Comments for referee of the paper “Charge Injection Devices” by Jaakko Härkönen et al.

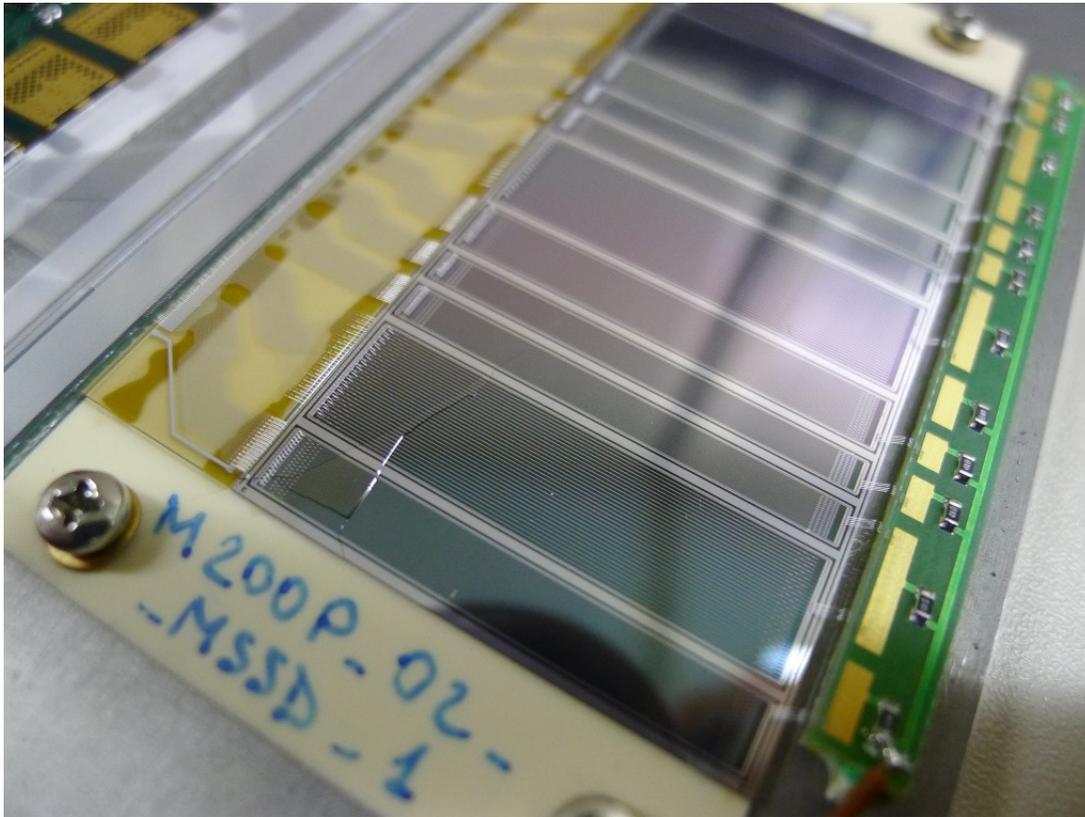
2. A comment on any (if any) practical difficulties encountered in operating at -50°C would be welcome e.g. due to different thermal expansion of materials used.

It is natural that thermal expansion might cause mechanical problems. In our test beams, such failures have actually never happened with CID modules cooled down to -50°C . One reason can be that in our setup, we place the sensor on support, which is PCB material:
